CUMBERLAND  
CITY COUNCIL

Council Ref: OA2024/0015

**Subject:** Request for Comments – State Significant Development (SSD)  
**Application No:** DA264-09-01-Mod-12  
**Property:** 14-54 Dennistoun Avenue YENNORA NSW 2161  
**Proposal:** Yennora Distribution Centre - MOD 12 - Building 2 (DA264-09-01)  
- 14-54 Dennistoun Ave Yennora NSW 2161

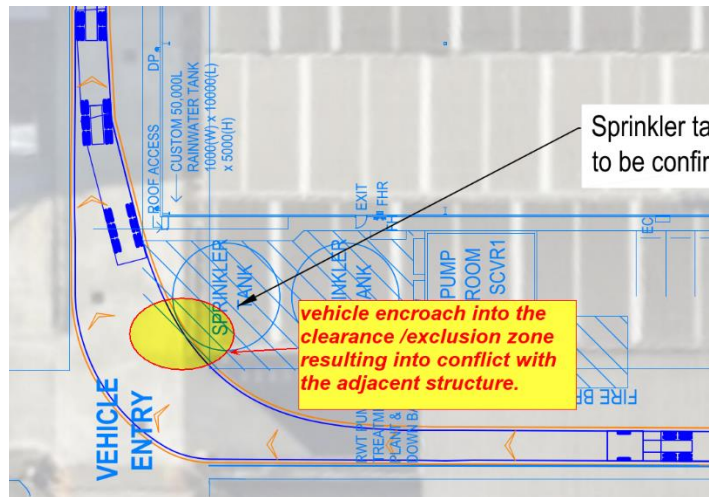
The architectural plan indicates provision of 99 parking spaces spreading around the subject building showing *38 parking spaces* in the vicinity of warehouse 01, 14 parking spaces adjacent to warehouse 02, and the 47 parking spaces at the front of the building located on the eastern side opposite to the proposed building (denoted as building no 7).

- ii. It is not clear whether the 47 parking spaces located in front of the eastern side building (denoted as Building 07 on the plan) are approved for use by the subject building. Documentary evidence will be required to substantiate this claim.

The applicant shall provide the plan of approved parking space with allocation for the building 2 including the total approved parking spaces and the associated respective GFA for each building.
